Product Change Notification - SYST-08UUHO160

ERRATA - dsPIC33CH128MP508 Family Silicon Errata and Datasheet Clarification

dsPIC33CH128MP508 Family Silicon Errata and Data Sheet Clarification

FIGURE 1: I/O RAMP

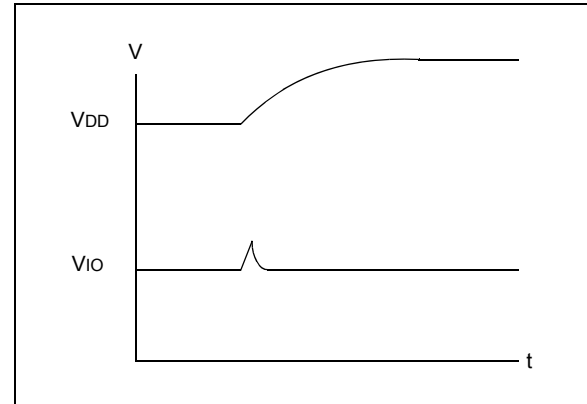
During a fast device power-up, when the V_{DD} ramp is less than 4 mS, the I/O pins may drive up to 100 μ A current for a duration of up to 10 μ S (Figure 1).

Example applications affected may include complementary power switches, where a transient current shoot-through might occur.

1. Slow down the V_{DD} ramp time (greater than 4 mS for V_{DD} to ramp 0V to 3.3V).
2. Ensure the circuitry that is connected to the pins can endure this pulse.

High-voltage applications with complementary switches should power the high-voltage 200 μ Sec later than powering the dsPIC[®] device to avoid the current shoot-through. This behavior is specific to each device and not affected by aging.
